Tender Documentation Report

Milton Ulladulla Hospital –
Cancer Centre and CT Imaging

Reference: S240439

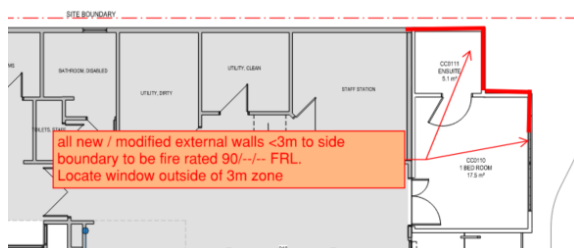
Comment: The new (and any modified) external walls of the Cancer Care extension are to achieve 90/-/- FRL as noted below, due to exposure to the side boundary. Fire rating is to extend minimum 3m lateral distance from the boundary.

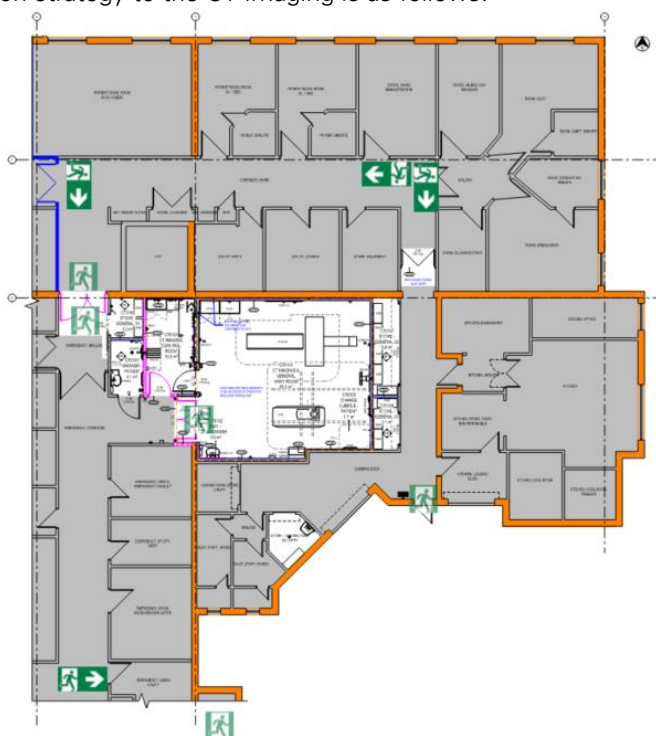
- + The cancer care facility is compliant with regard to compartment areas.
- + Compartmentation strategy to the CT Imaging is as follows:-

All new and modified fire walls (in pink shade) are to achieve –/120/120 FRL, fire doors located therein are to achieve –/120/30 FRL
Minimum 400mm reservoir required above all new and modified fire doors (x3).

- + As part of the project delivery, all existing fire walls that immediately bound the CT Imaging zone, are to be upgraded to the degree necessary to ensure –/120/120 FRL.
Audit of existing walls will be necessary.
- + The area shaded in yellow below is to be confirmed to have a maximum compartment area of 500m², noting the CT Imaging is in the same compartment as the existing ward area.

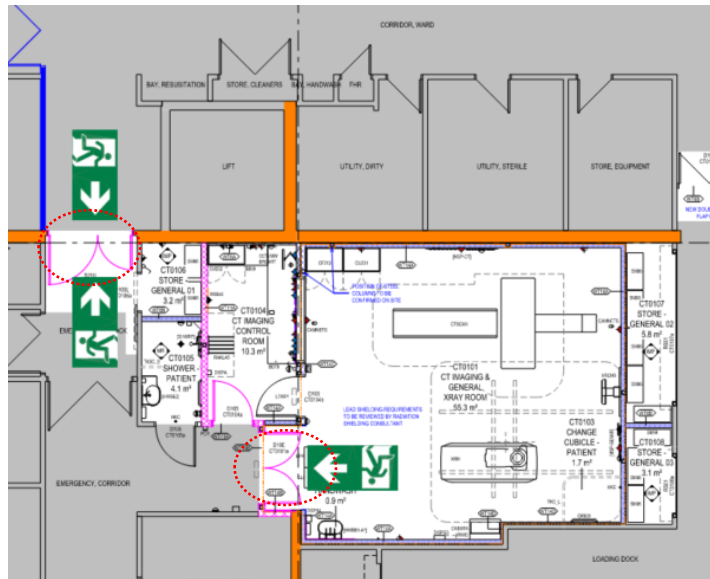
Fire doors in the CT Imaging circled below are to swing in direction noted with arrow:-

Where swing in the direction noted is not achievable for operational reasons, this is to be addressed in the fire engineering assessment as part of the Crown Certification stage.

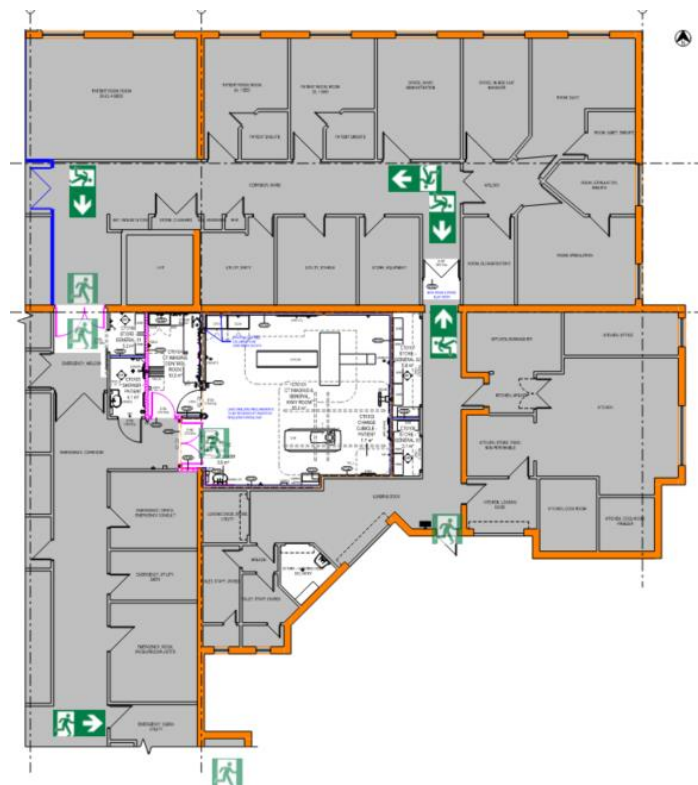
Egress from the Cancer Care is as below – ensure exit signage is provided over nominated exit doors and directional signage is provided to the degree necessary:-

Egress from the CT Imaging is as below – ensure exit signage is provided over nominated exit doors and directional signage is provided to the degree necessary:-
